# Errata

## SLG46517

### CE-GP-001

*This document contains the known errata for SLG46517 and the recommended workarounds.*

Figure 1

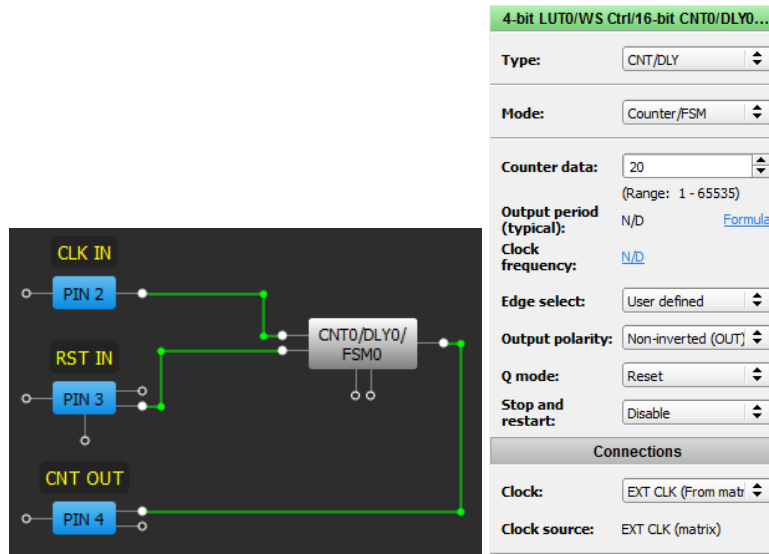
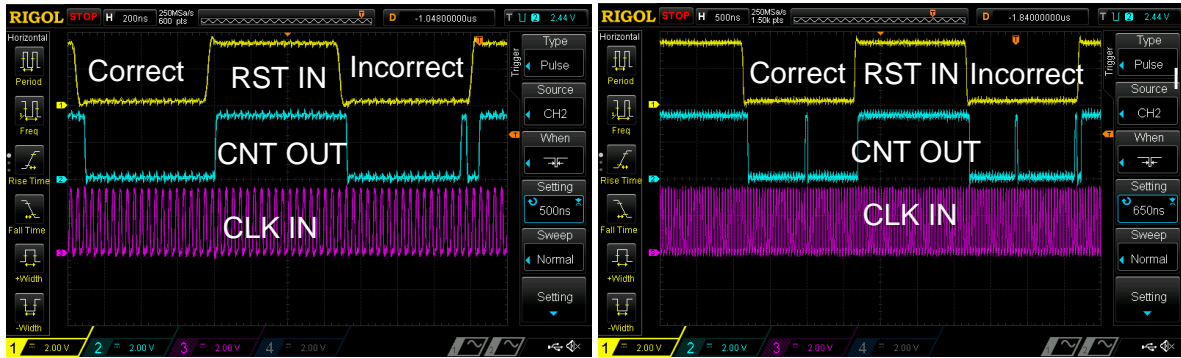
If the Counter Reset is asserted at the same time as a rising clock edge, it is possible that the Counter Data will be reset incorrectly and the counter output may appear faster than expected. This phenomenon appears more often as the clock frequency increases.

Figure 3

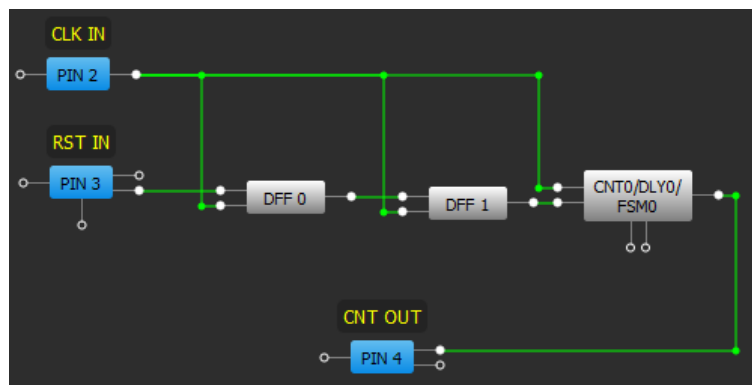
Synchronize RESET input of the Counter with its CLK using 2 DFF cells as shown on Figure 3.

Figure 4

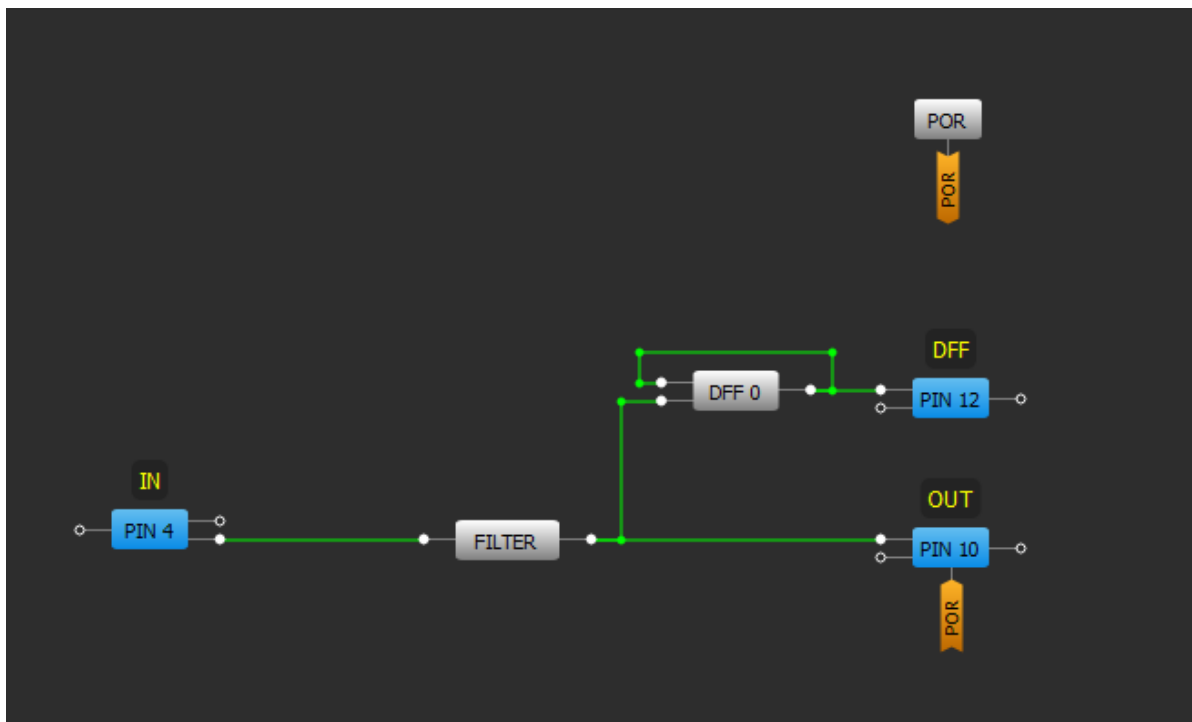
If clock type high frequency input comes in, the FILTER cell may not filter out it. There are several factors like input frequency, duty cycle and LOW duration in such signal that may lead to its passing through FILTER block.

Currently there is no workaround for this issue. Filter block is good at filtering short spontaneous glitches. It is intended to be used in series connection before the delay cell to avoid its latching.

Figure 9

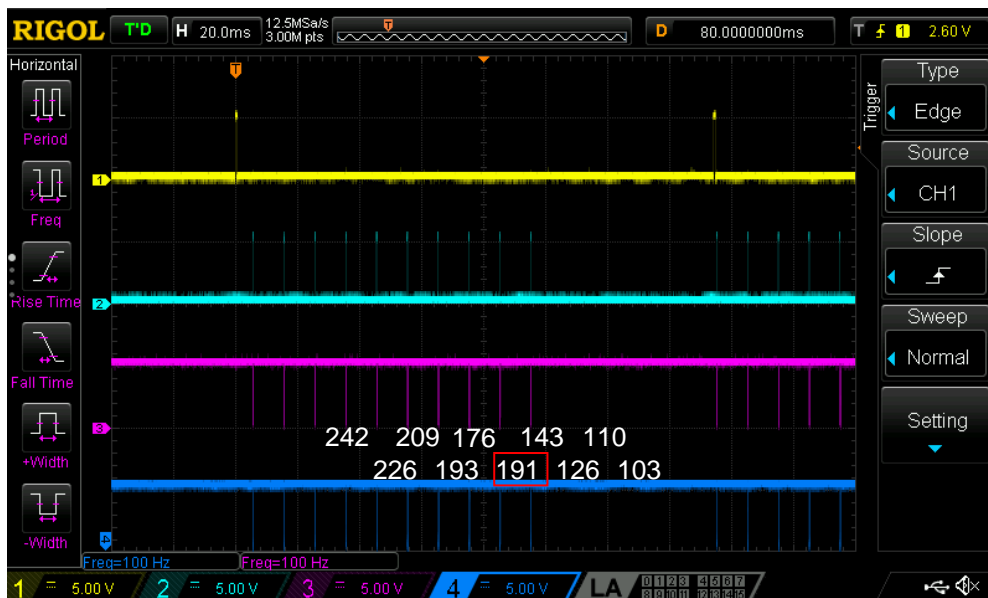
Asynchronous interaction between the CNT/DLY clock input and the I2C latch signal (generated by an I2C read command of the CNT/DLY block's count value) can result in an incorrect I2C data read. The CNT/DLY block will count accurately, but the count value transferred into the block's I2C read register might be loaded incompletely if the I2C latch signal and the clock input occur at about the same time.

The example data capture below shows ten periodic I2C reads of CNT2/DLY2 configured to count down at about 16 clocks per read. The sixth read sample erroneously shows a value greater than that of the fifth. The seventh sample reads as if the previous I2C error never occurred - the difference from the fifth sample (176) to the seventh (143) is 33 clocks or 16 clocks + 17 clocks as expected.

If the possibility of incorrect I2C data reads can't be accommodated for by external software checks, one can guarantee proper operation by stopping the CNT/DLY block's clock during I2C reads

through one of the following methods: by disabling the oscillator block, by reconfiguring the CNT/DLY block's clock source, or by gating an external clock using a LUT (Look-up Table) in the signal matrix. After disabling the CNT/DLY block's clock, the count registers can be read without error. Please note that this workaround will add the I2C read and processing time to the counter's overall clock period.

Figure 10: I2C Write of 16-Bit Counter Data Example

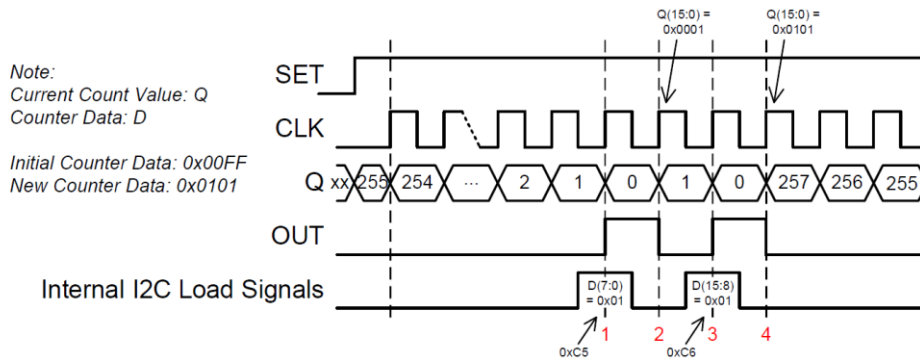
The timing diagram in [Figure 10](#) sets up a case where an improper output will be seen on the counter. In this example, the initial Counter Data value (D) is set up as 0x00FF. As you can see, the

Current Count Value (Q) decrements from 255 down to 0 with rising edges on CLK. At time “1” denoted by a red number 1, an I2C command (not shown) has just been sent to the GreenPAK device to reconfigure the Counter Data value to 0x0101.

As previously mentioned, the 16-bit value is loaded from the I2C buffers to the Counter Data registers in 8-bit chunks. Right at time “1”, the LSB byte (0x01) is loaded into the Counter Data registers. This makes the Counter Data value temporarily equal to 0x0001. At time “2” between the internal I2C load signals, the counter receives a rising edge on its clock input. This causes the Current Count Value to underflow and to be loaded with the Counter Data value which is 0x0001. At time “3”, the MSB byte (0x01) is loaded into the Counter Data registers setting the Counter Data value to 0x0101. At time “4”, the Current Count Value underflows again and is set to the Counter Data value of 0x0101.

Figure 11: 16-Bit I2C Counter Block Diagram

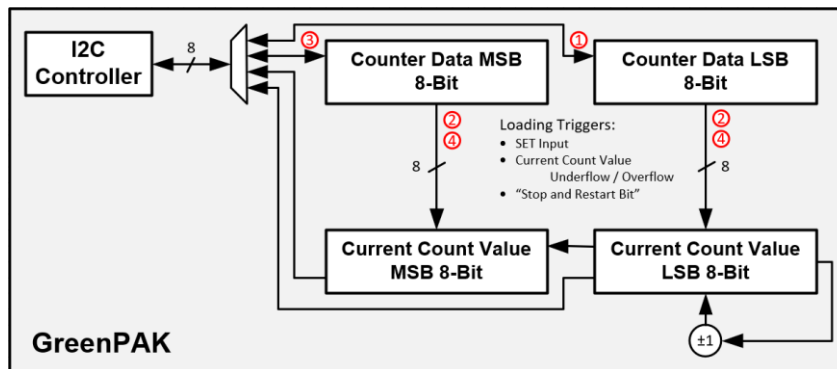
This behavior results in two output pulses on OUT when only one pulse is expected. Observing this behavior depends upon the asynchronous timing between the counter’s clock and the I2C write command to the Counter Data registers. For some applications, the extra pulse on OUT can be ignored and the counter will self-correct after underflowing, overflowing, or being SET/RESET through the GreenPAK connection matrix.

Figure 12: Counter Behavior

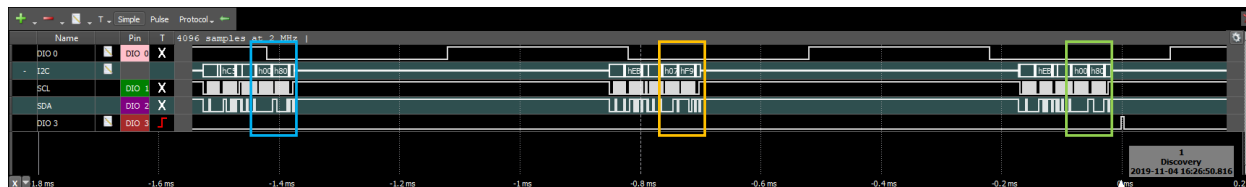
For the following condition, the Counter Data register contents are unexpectedly loaded into the counter’s DFF chain. This behavior occurs when there is a falling edge on the counter block’s clock input during the data return portion of an I2C read of the Counter Data registers. Figure 10 shows this falling edge boxed in light blue followed by two I2C reads of the Current Count Value registers.

As you can see by the MCU data log below, the Current Count Value gradually increases from 0xF904 to 0xF907 but is unexpectedly reset to 0x8000. Please note that the colored HEX values in the MCU Log correspond to the boxed I2C read commands shown in the waveform above. As previously described, this reset occurs because there is a falling edge on the counter’s clock input while the GreenPAK device is responding to an I2C read request to 0xC5 and 0xC6. (Note that 0xC5/0xC6 are the Counter Data registers and 0xEB/0xEC are the Current Count Value registers for CNT0.)

Figure 11

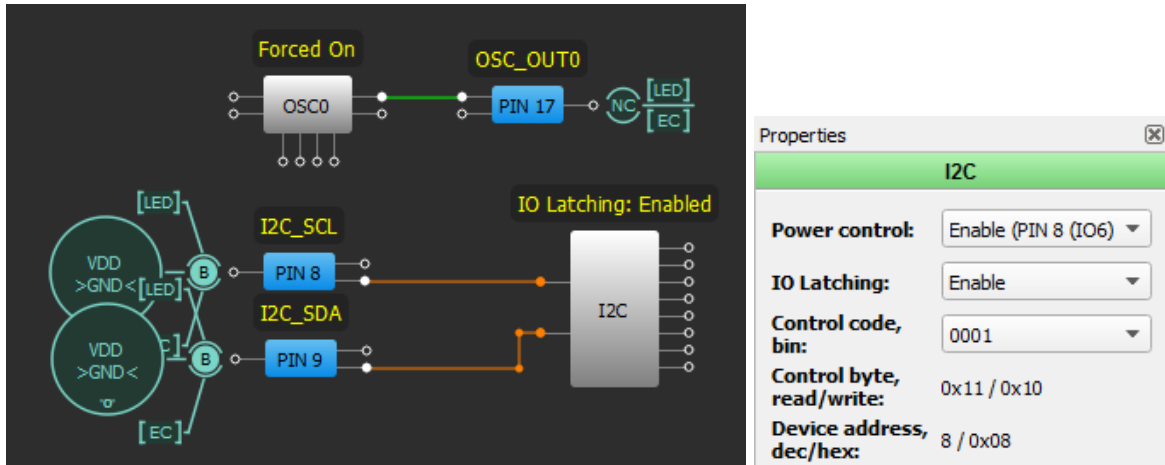
In the example below, we will be monitoring the OSC output, which is measured by a scope on Channel 3 via PIN17 ("OSC\_OUT0"). The I2C bus will be forced low to create a START bit.

By toggling I2C\_SDA low and then I2C\_SCL low, the GreenPAK registers this as a start bit and latches all General Purpose Outputs such as PIN#17(“OSC\_OUT0”). In the Figure 12, notice that PIN#17 (OSC\_OUT0) stops toggling.

Disable IO Latching in programmed OTP. This register is I2C-write locked during normal operation and therefore should be disabled in configuration file.  
Do not share I2C bus with other devices and make sure the I2C bus is not powered down while the GreenPAK is still powered through VDD.
